## INTRODUCTION

We are glad to be providing this response to the neighborhood's compiled set of questions and comments regarding Meadow Way Bridge, initially emailed on September 4, 2013 by Mr. Alexander Binik to the Council. Town staff summarized the list of questions and comments and presented it to the City Council in October 2, 2013. The new form of the questions to be responded to was accepted by Mr. Binik in a subsequent email. At the October 2, 2013 Council meeting, the Council agreed that the core options to be considered are: 1) repair the existing wooden bridge, 2) replace the bridge with a one-lane wooden bridge, and 3) replace the bridge with a one lane concrete/steel bridge.

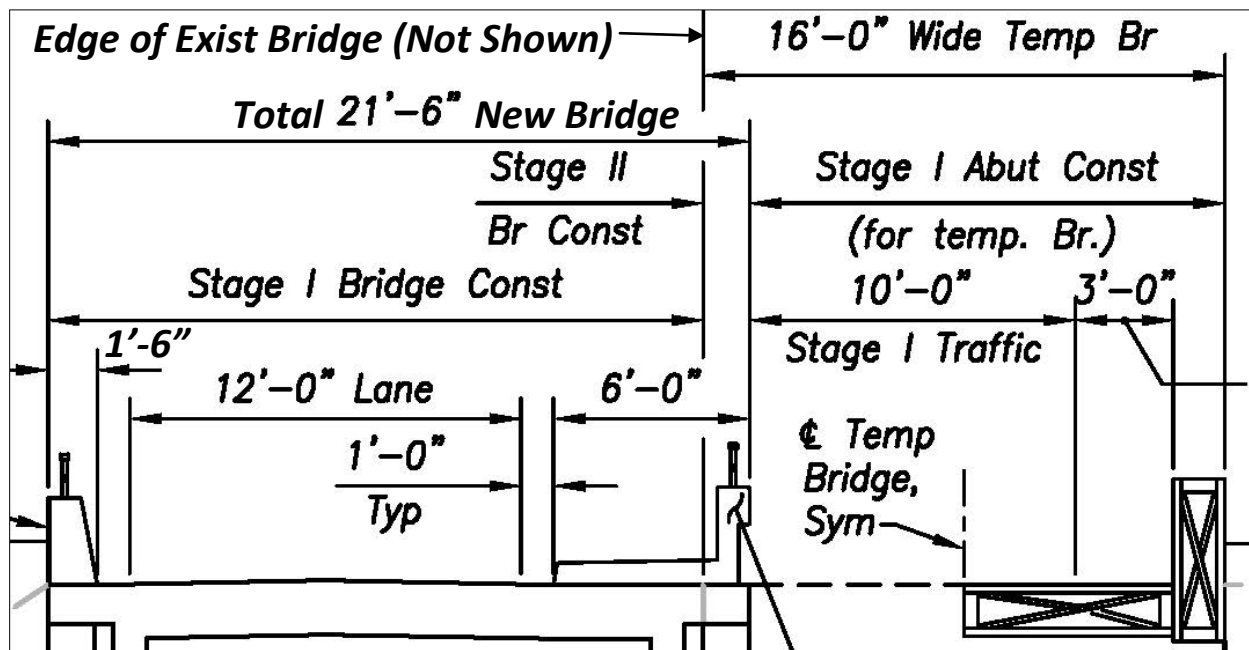
Wooden as well as other types of bridges made from concrete or steel are all feasible at this site. The ideal bridge would clear-span the creek, obviating the need for supports in the creek that impede the flows and collect debris and drift. Bridge replacement will require a temporary bridge alongside of the existing, as shown on the plan view (looking down on the bridge), below:

The temporary and permanent bridge footprints will remain within the public right-of-way, which will be accurately established during the future phase of the project. The construction sequence will entail constructing the abutments and retaining walls on the south side and placing a single-span temporary bridge right alongside of the existing bridge with the aid of one or two cranes. Depending on the

creosote issue, we may consider cutting a 2-foot wide strip out of the south edge of the existing bridge to place the temporary bridge that much farther away from the homes on the south side. This will happen just before the temporary bridge is lifted to be placed on its abutments. Subsequently, the local traffic will be directed to the temporary bridge and the existing bridge will be removed. The existing bridge will likely need to be taken down piece-by piece and isolated to control the spread of contaminants. Once the bridge is totally removed, the abutments for the new bridge and the retaining walls on the north side of it will be constructed, making way for construction of the new bridge superstructure. The deck of the new bridge may have to be constructed in two stages, the bulk of which will be done in the first stage. A narrow edge strip overlapping with the temporary bridge may be constructed after traffic is placed back on new bridge and the temporary bridge is removed.

**Cross Section of the New and Temporary Bridges**

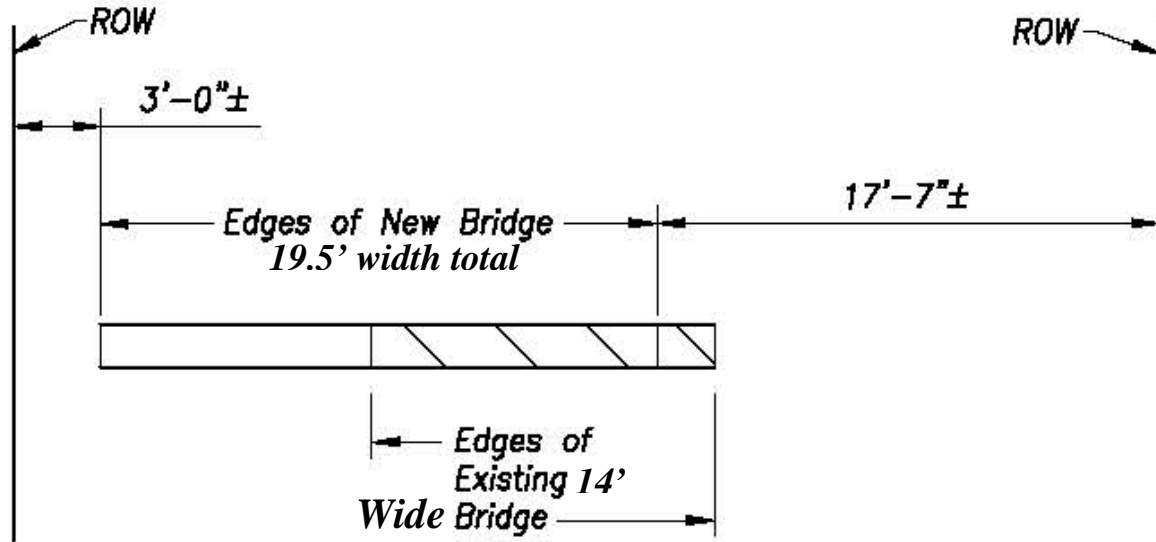
The CIC team has performed preliminary studies and cost analysis of three bridge concepts made from wood, concrete or steel. Each bridge will clear-span the creek. The new bridge may have one standard 12' lane, a 1' shy-away strip on each side of the lane, a 5'-wide sidewalk on the south side and safety rails on each side of the deck, as shown below:

The bridge will have a span of 70-80 feet supported by abutments on the creek banks at each end. Flanking these abutments will be retaining walls on each side to stabilize the creek bank approaches to the bridge. The foot of the retaining walls and bridge abutment walls and the creek banks housing the walls will be armored with rock riprap. (See the plan view on page 6.)

The one-lane provision will still need to be approved by Caltrans as a "Design exception," but we believe the existing conditions would support such a request. In comparison, the existing bridge is 14 feet wide with a 10-foot lane for traffic, 2.5 feet for pedestrian walkway, and 1.5 total feet for railings and a separator strip. The minimum Caltrans standard for a new bridge is 19.5 feet wide with 12 feet for traffic lane, 5 feet for pedestrians/bikes, and 2.5 feet total for safety rails on both sides. The diagram below shows the dimensions and relative locations of the existing bridge and a new bridge of minimum width,
